# #3024585-LU

412 NW 65TH ST RECOMMENDATION PACKET

412 NW 65TH ST  
SDCI# 3024585-LU

EDG PERSPECTIVES: SCHEME C: NARROW + ARTICULATED (PREFERRED)

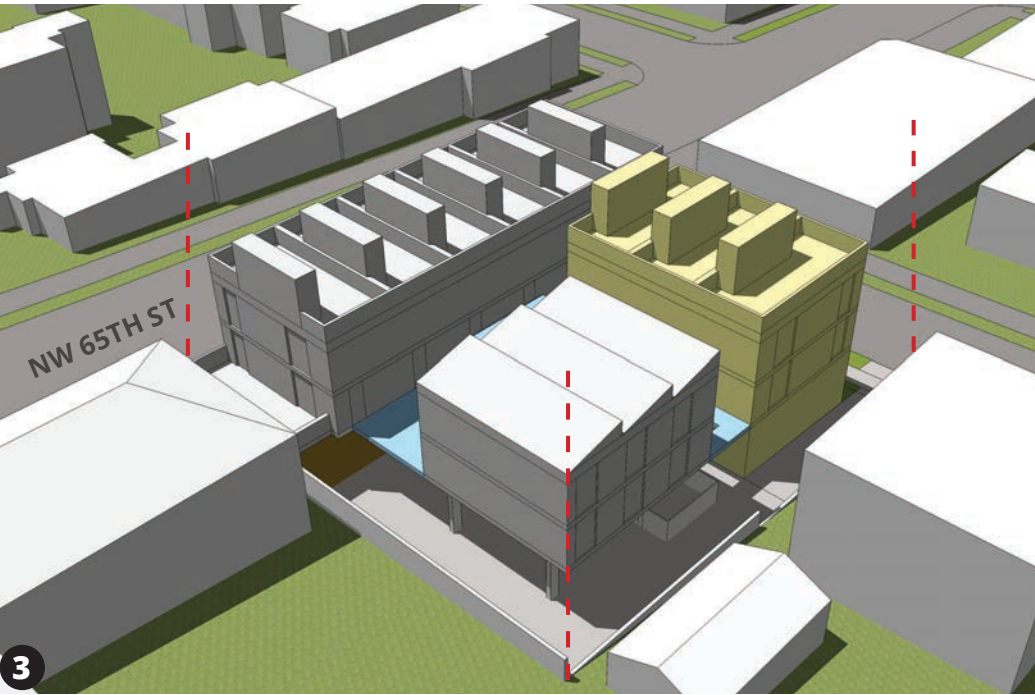
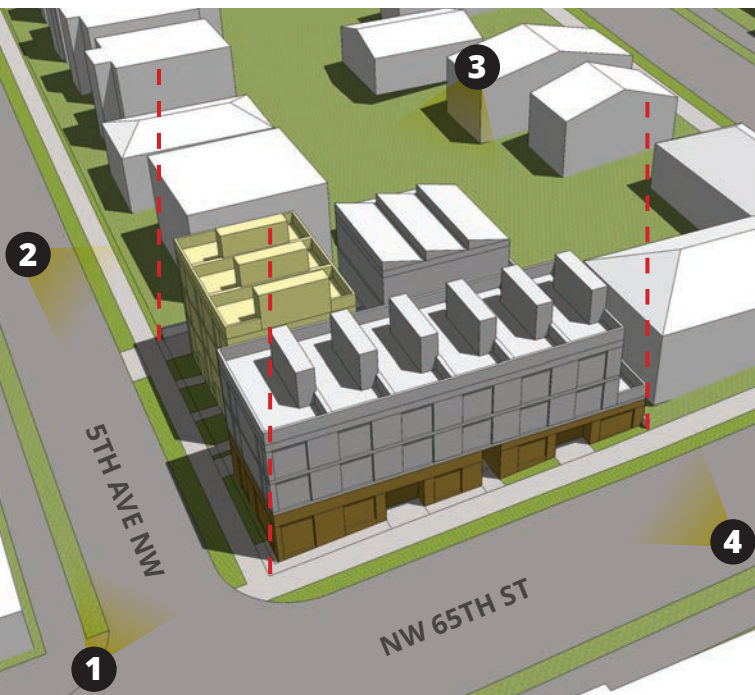
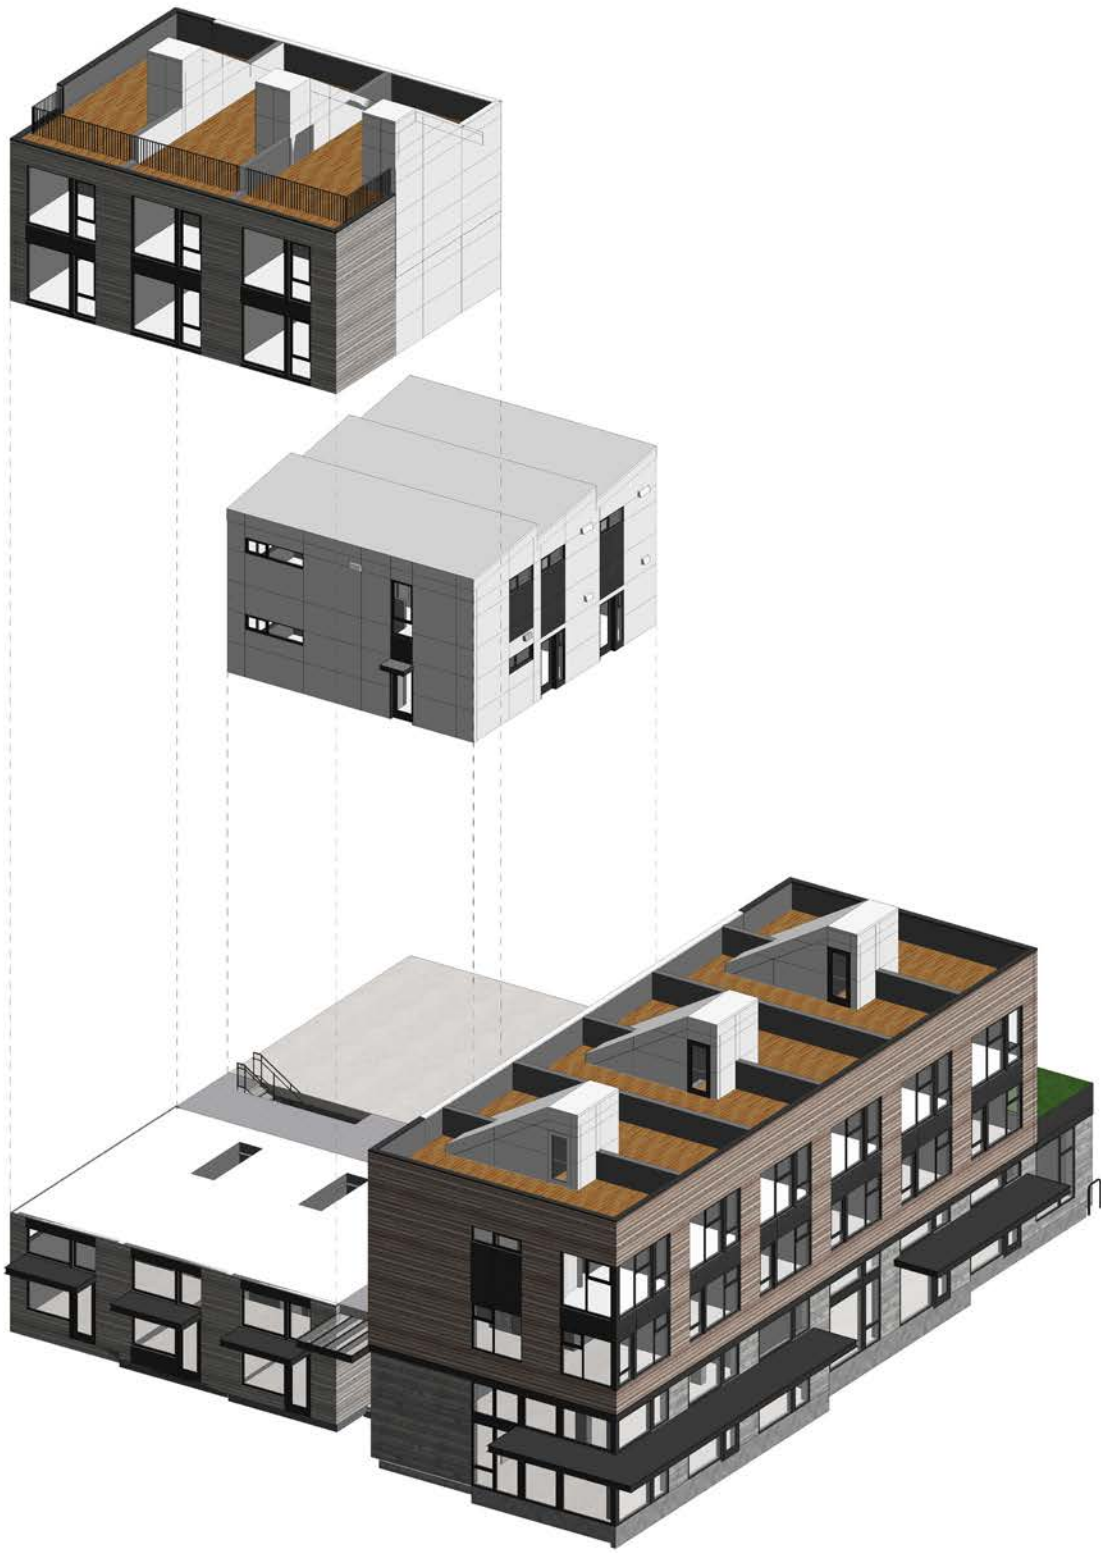
BOARD COMMENTS OF SUPPORT:

- THE BOARD VOICED UNANIMOUS SUPPORT FOR THE PREFERRED DESIGN OPTION C
- THE BOARD STATED THAT THE DESIGN SHOULD MAKE AN EFFECTIVE TRANSITION TO THE SINGLE-FAMILY ZONED PROPERTY TO THE NORTH AND LOW-RISE ZONED PROPERTY TO THE EAST
- THE BOARD APPRECIATED THE GENEROUS SETBACK OF THE PROPOSED LIVE-WORK UNITS' ENTRANCES FROM THE SIDEWALK EDGE
- THE BOARD APPRECIATED THE ARRANGEMENT OF THE STREET LEVEL USES AND THE INTENT TO PROVIDE OVERHEAD WEATHER PROTECTION IN SCHEME C

## 1 DEPARTURE   SMC 23.47A.014.B.1: RESIDENTIAL ZONE ABUTMENT

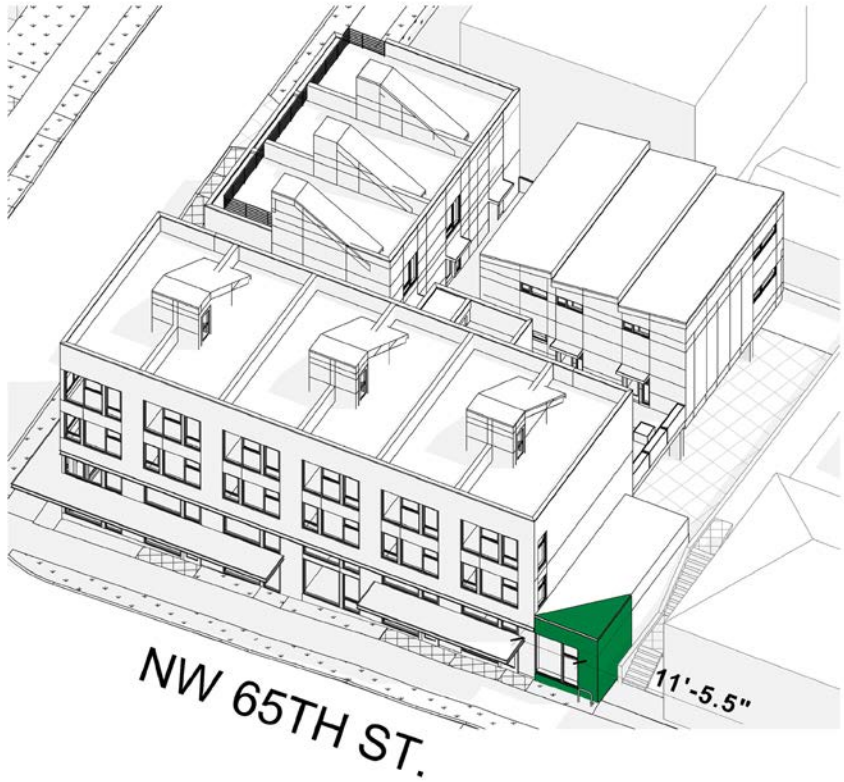
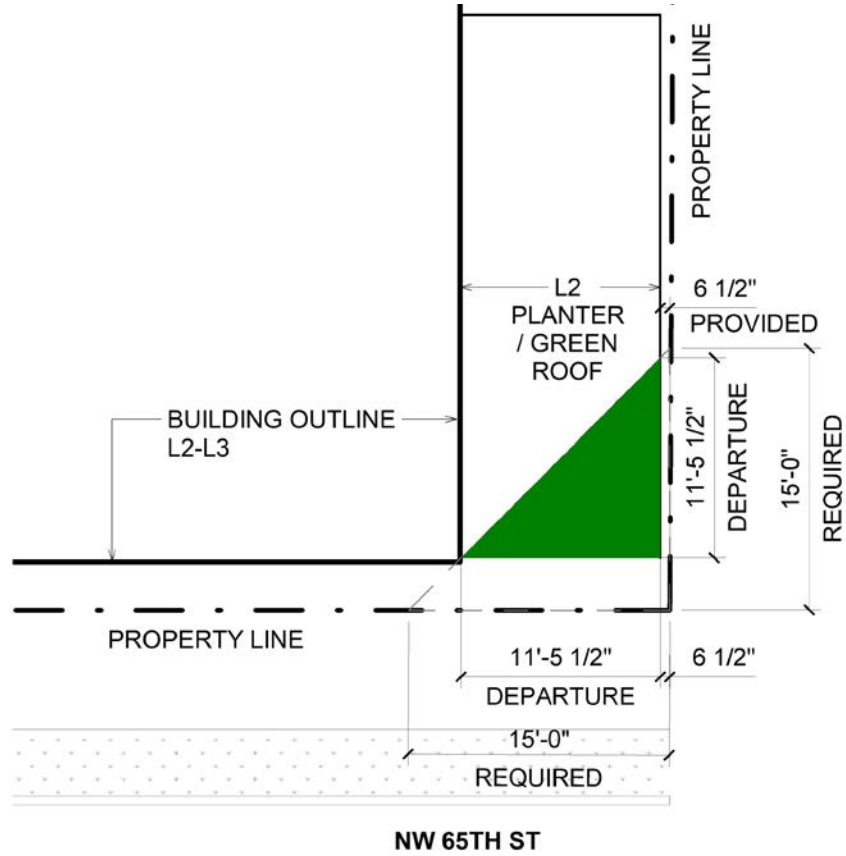
**BOARD:** THE BOARD INDICATED A WILLINESS TO ENTERTAIN THIS DEPARTURE AND WAS IN AGREEMENT WITH THE JUSTIFICATION PROVIDED.

**PROVIDED:**  
3.5' x 3.5' TRIANGLE IS PROVIDED AT THE SOUTHEAST PROPERTY LINE, COMPLIANT AT NORTHWEST PROPERTY LINE. 11'-5.5" TRIANGLE DEPARTURE REQUESTED AT THE SOUTHEAST CORNER.

**JUSTIFICATION:**  
THE TRIANGULAR SETBACK ALONG NW 65TH ST. BREAKS UP THE COMMERCIAL CHARACTER AND CONTINUITY ON NW 65TH ST., AND CREATES A NON-DESIRABLE EMPTY SPACE ALONG THE STREET. THE REQUESTED DEPARTURE ALLOWS A MORE COHERENT STREET EXPERIENCE. ADDITIONALLY, THE RETAINING WALL AND ELEVATED SIDE YARD CONDITION TO THE EAST MINIMIZES THE DEPARTURE IMPACT. IN ADDITION TO THE DIAGRAMS PROVIDED HERE, SEE IMAGES AND ADJACENCY DIAGRAMS ON PAGE 26.

## 2 SETBACK AT RESIDENTIAL ZONE SMC 23.47A.014.B.3: SETBACK AT RESIDENTIAL ZONE

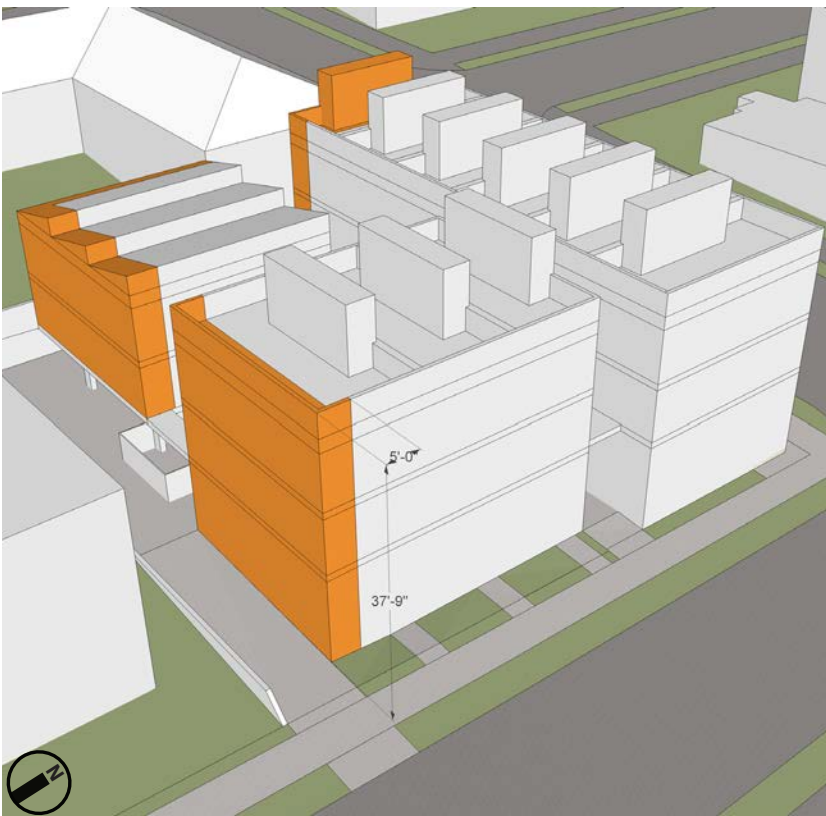
**BOARD:** THE BOARD DID NOT SUPPORT THIS DEPARTURE AS IS AND REQUESTED A MORE COMPELLING ARGUMENT TO BE PRESENTED WITH SUPPORTING DOCUMENTATION SUCH AS WINDOW STUDIES.

**REQUEST:** REDUCED BY 3'-2" ALONG EAST AND 1'-2" ALONG THE NORTH. MOVING THE PENTHOUSE AWAY FROM EAST PROPERTY LINE ALSO REDUCED THE DEPARTING HEIGHT.

## 3 SIGHT TRIANGLE SMC 23.54.030.G.4: SIGHT TRIANGLE AT LOT LINE

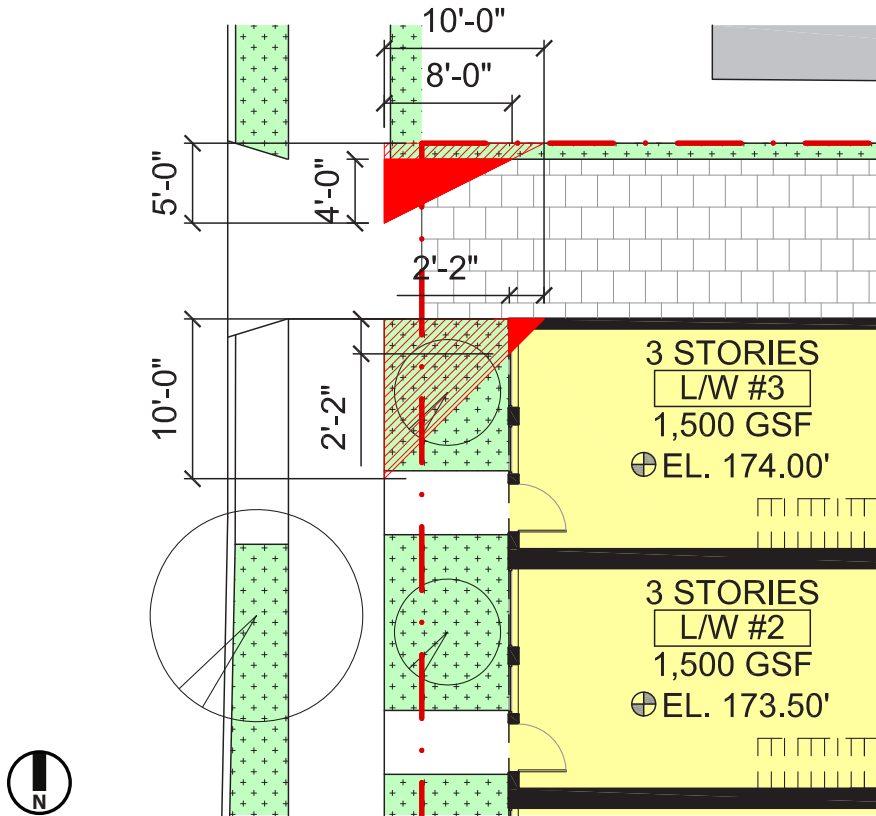
**BOARD:** THE BOARD INDICATED A WILLINESS TO ENTERTAIN THIS DEPARTURE AND WAS IN AGREEMENT WITH THE JUSTIFICATION PROVIDED.

**REQUEST:** MAINTAINED
